From: Allen Dawson <allen.dawson@benjamin-allen.co.uk>
Sent: 08 February 2026 12:27:35 UTC+00:00
To: "Joanne Fisher" <Joanne.Fisher@midsussex.gov.uk>
Subject: RE: DM/25/3225 - Townhouse Farm

Whilst we wait for the amended landscaping plan, please see attached the additional information requested.

– Traditional opening flush Entrance door, French doors and Boot room door frame and leaf head Dwg. 2309

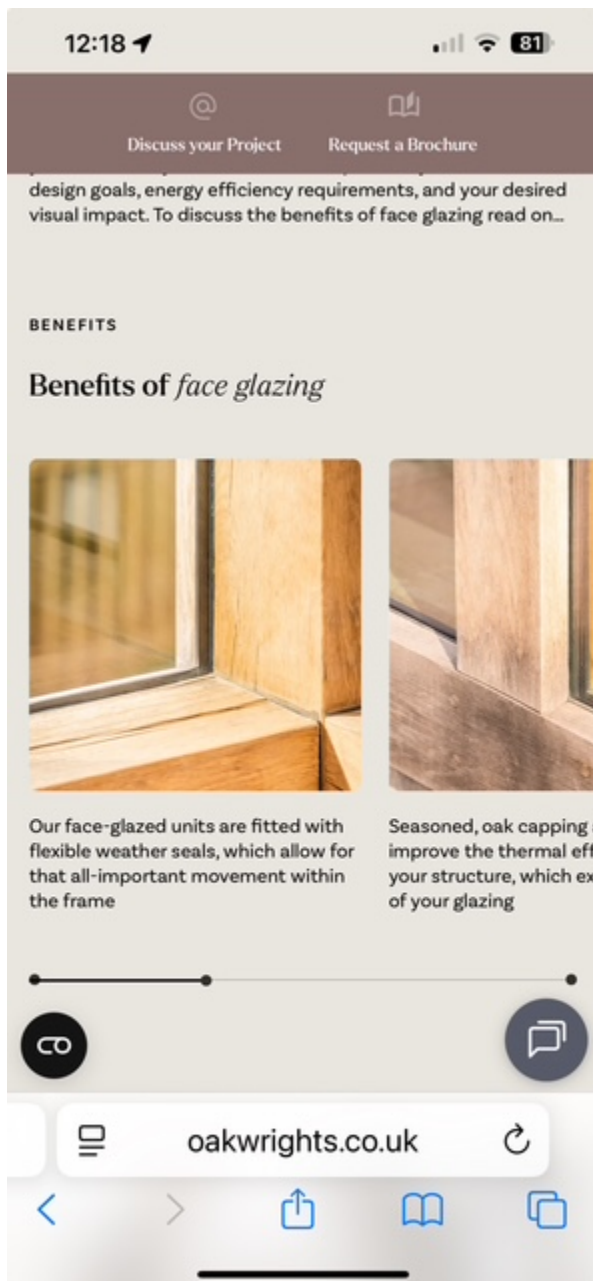
Doors –
